**FIRST AMENDMENT TO
REQUEST FOR PROPOSALS:**

**FOR CONSTRUCTION SERVICES RELATED TO THE
ROGER WILLIAMS PARK GATEWAY PROJECT
LOCATED AT 1197 BROAD STREET**

ADDENDUM 01

Project Name: Roger Williams Park Gateway Center
Date: April 6th, 2021
Project No: 2717.00

1 VENTILATED FACADE @ SINTERED STONE
ENLARGED WALL SECTION

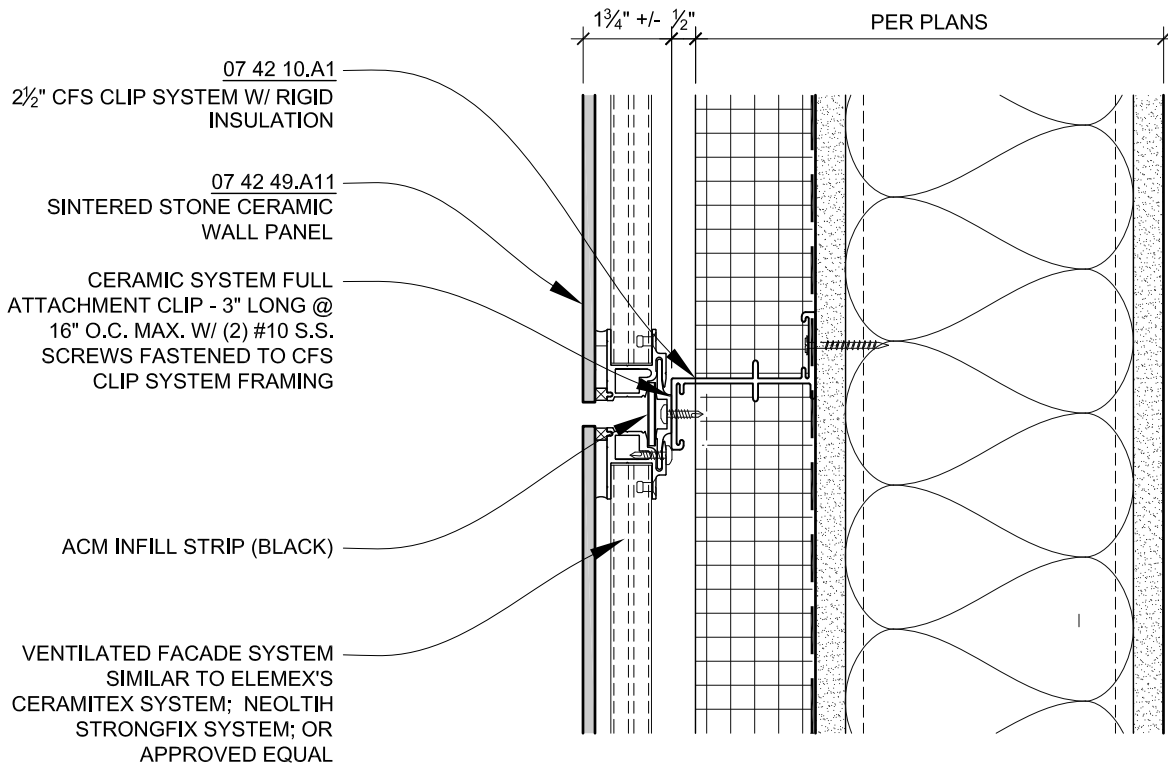
1. Provide alternate pricing for ventilated facade system at 07 42 49.A1 - SINTERED STONE CERAMIC WALL PANELS in lieu of 07 42 49.B1 - THINSET MORTAR over 07 42 49.C1 - 1/2" CEMENTITIOUS BACKER BOARD – at building enclosure. Per manufacturer instructions, 07 42 49.A1 - SINTERED STONE CERAMIC WALL PANELS shall be mounted over aluminum sub-framing with an air space and secured to 07 42 10.A1 – 2 1/2" CFS CLIP SYSTEM W/ RIGID INSULATION. Note – per the attached detail, the CFS CLIP SYSTEM is to be extended by 1/2" to achieve the air space. Ventilating facade system shall be inclusive of all manufacturer sub-frame support structure, fastening systems, flashing/closure components and, if required by manufacturer, blackout weather barrier.

1 DEMOLITION PLAN
 SCALE: 1"=10'

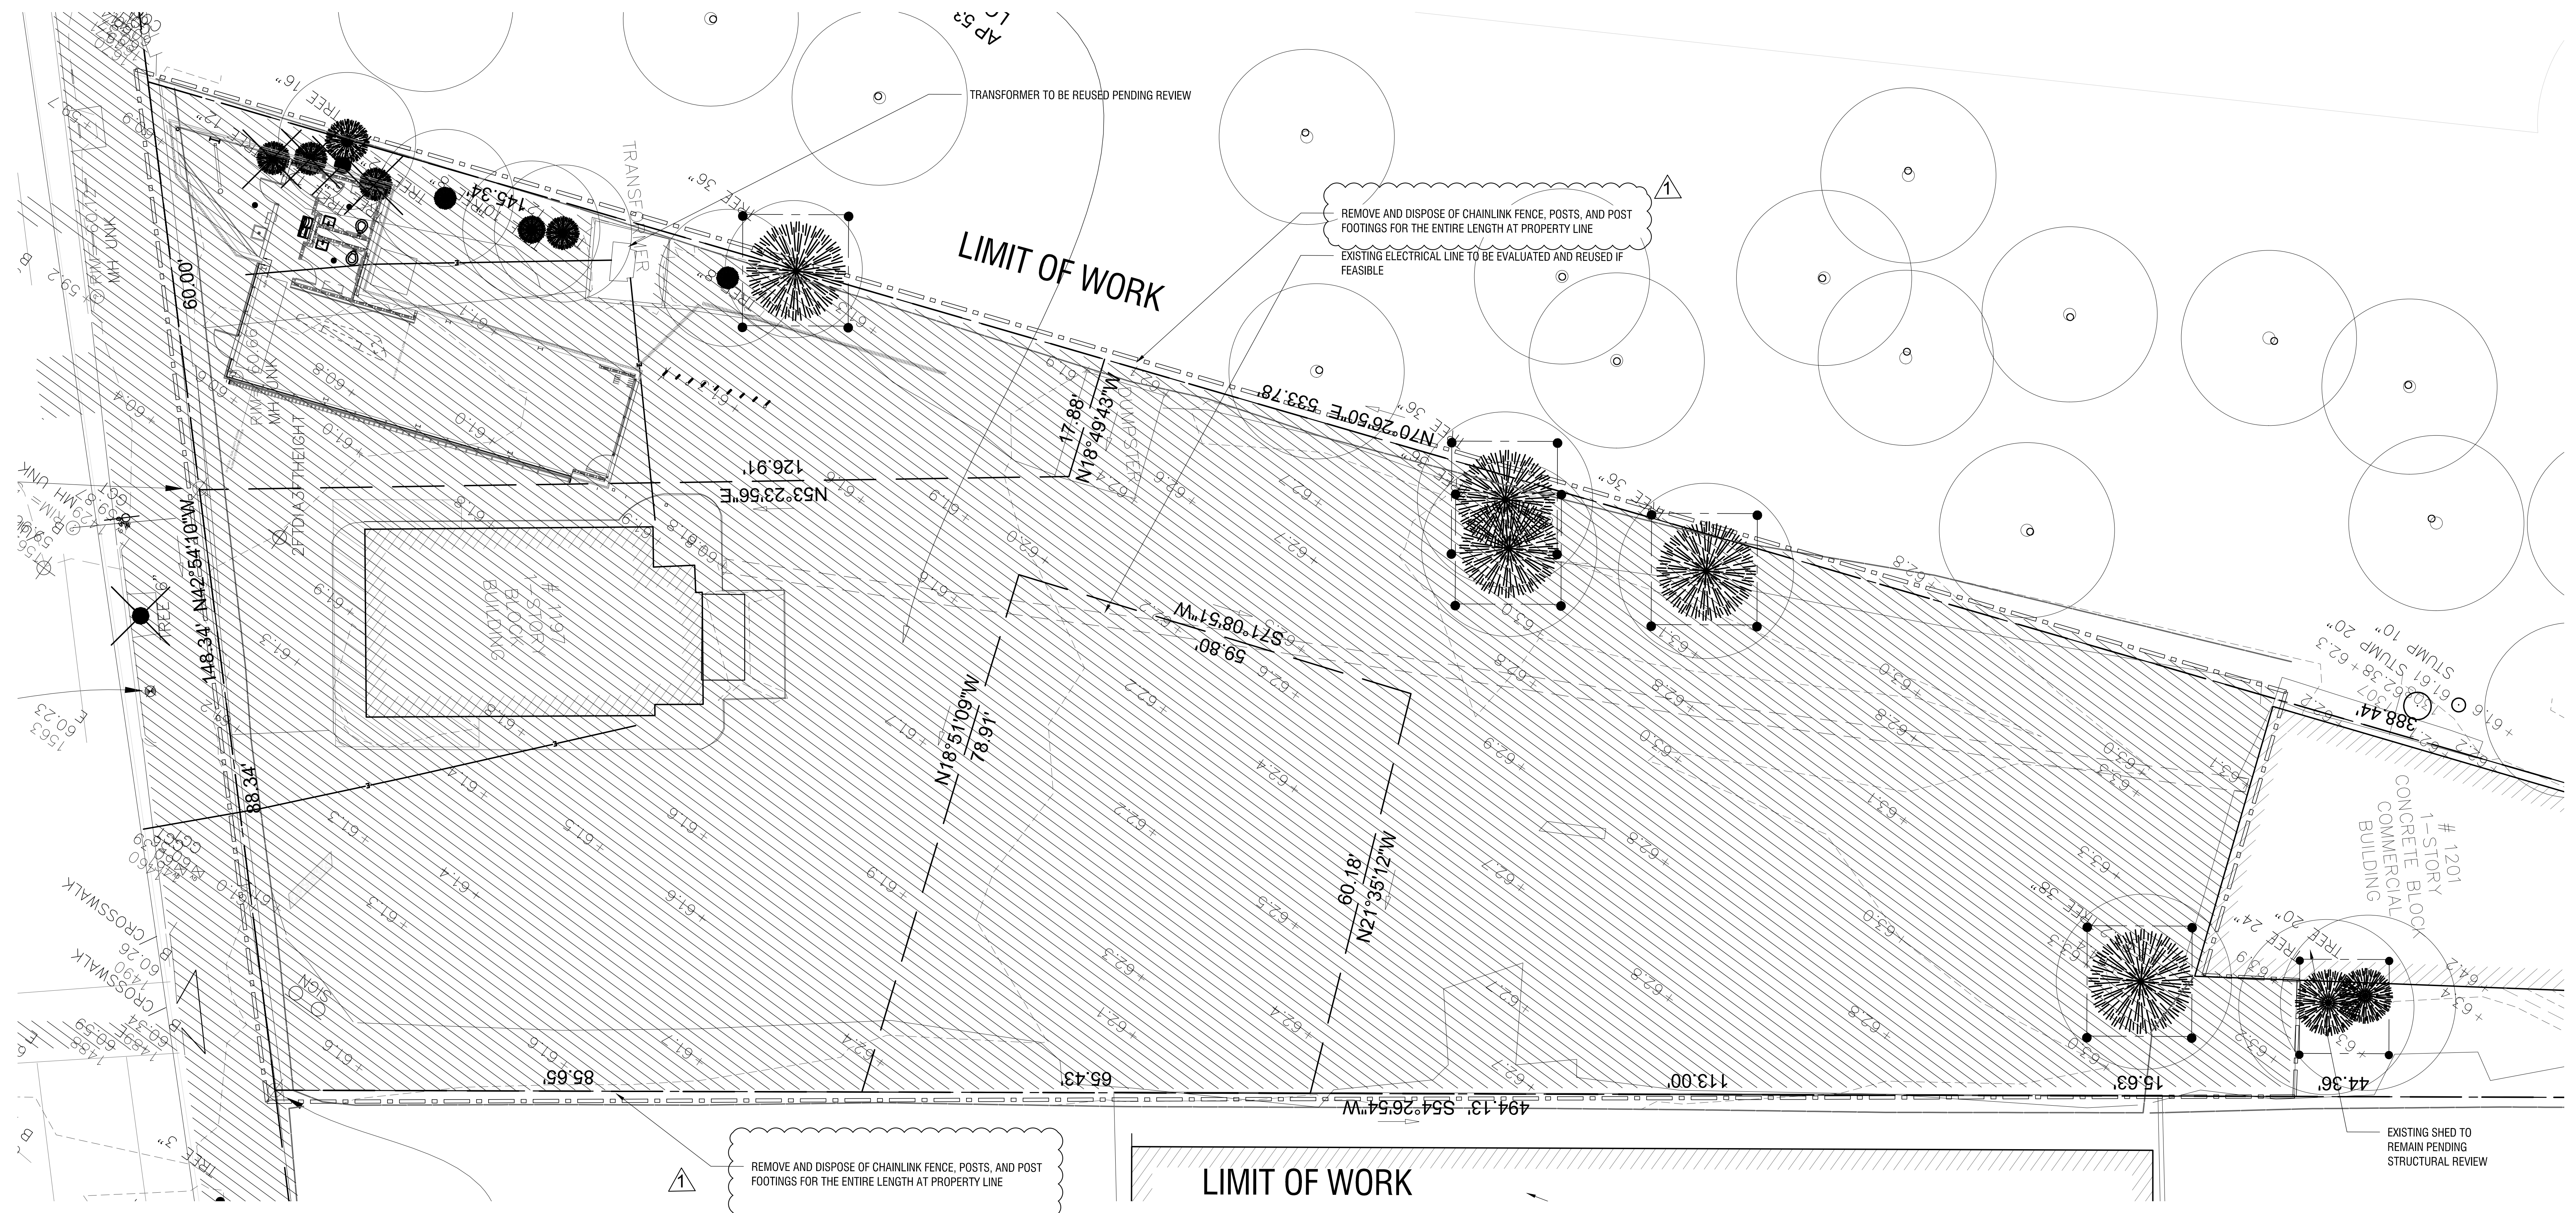
L-0.00 SITE DEMOLITION PLAN

1. Added note completely remove and legally dispose existing chain link fence and razor wire at areas bubbled in the plans.
2. Added note to indicate that tree removal will be performed by the Providence Parks Department prior to mobilization. All clearing and grubbing of the vegetation 5'-0" beyond the existing fence line will be performed by the Contractor in addition to all debris removal in that same area.

4. Added the following note to the demolition plan:
Removal of any/all existing hazardous materials / asbestos encountered during the demolition and construction of this project shall be performed by a State of Rhode Island licensed asbestos abatement contractor who is properly insured for hazardous material abatement. All hazardous material / asbestos abatement shall comply with Federal Standard 29 cfr 1926.58 and all other applicable federal and/or State of Rhode Island regulations.

DATE PLOTTED:
 MATERIAL PLAN

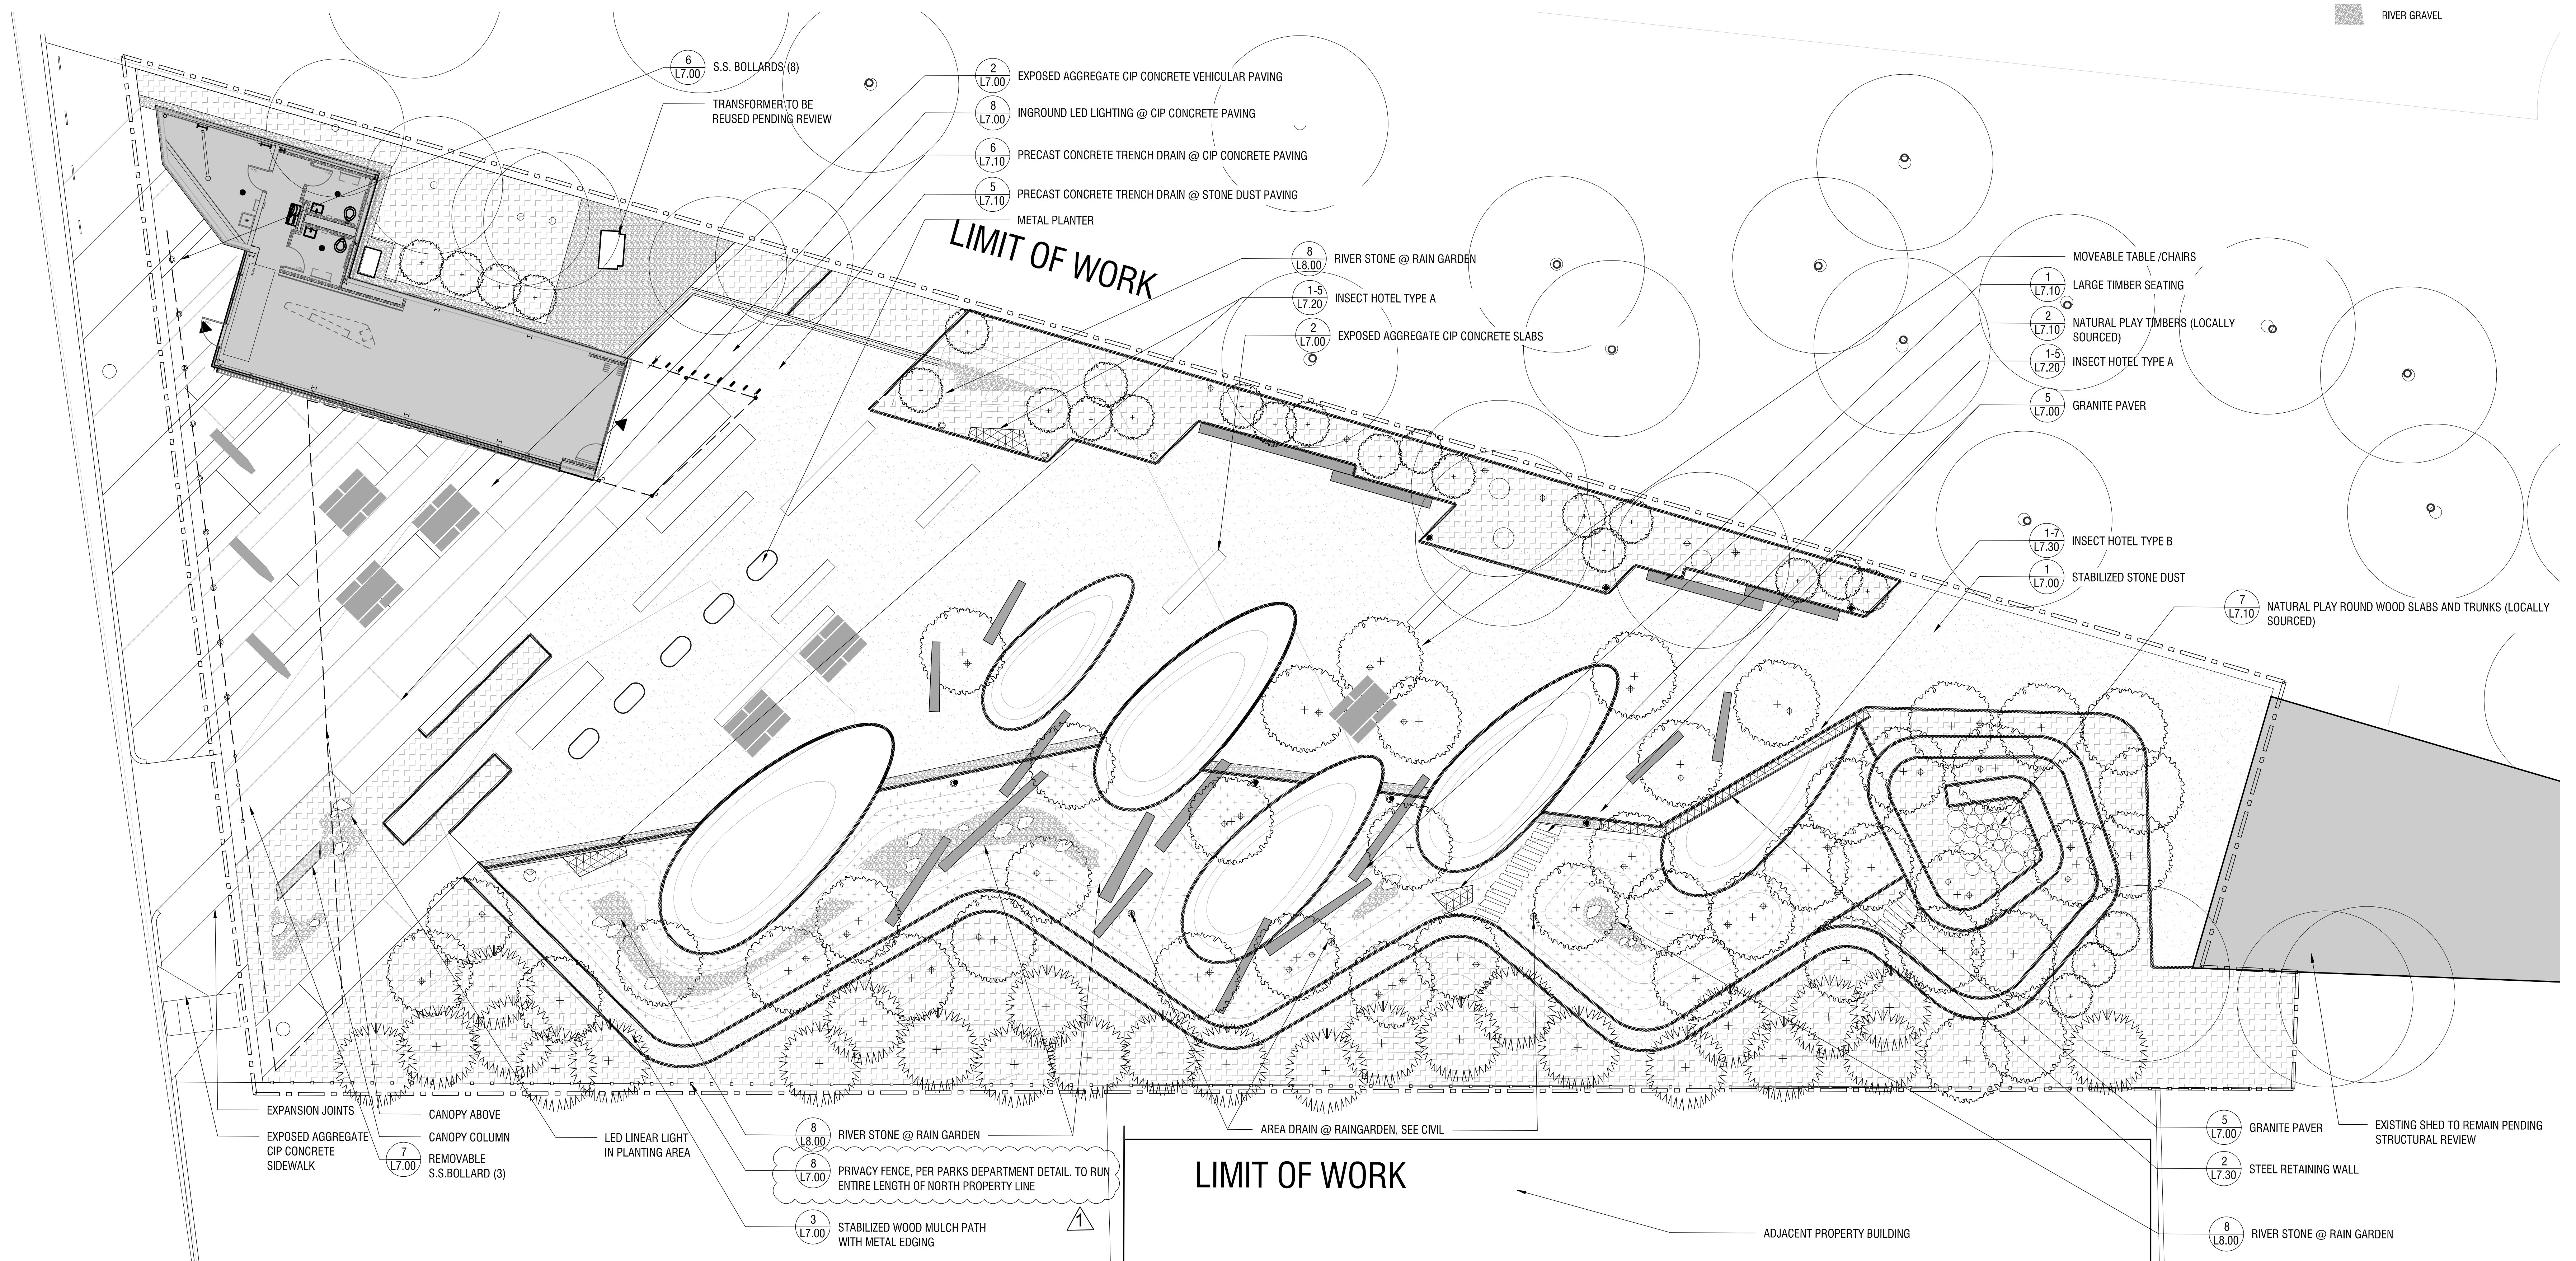
L-2.00-MATERIAL PLAN

3. Added PVD Parks Dept. standard welded wire fence (Patriot Ornamental Wire Fence - 72" high 4 gauge vertical) to be installed along the north property line as indicated in the plans. See attachment for specifications and installation instructions.
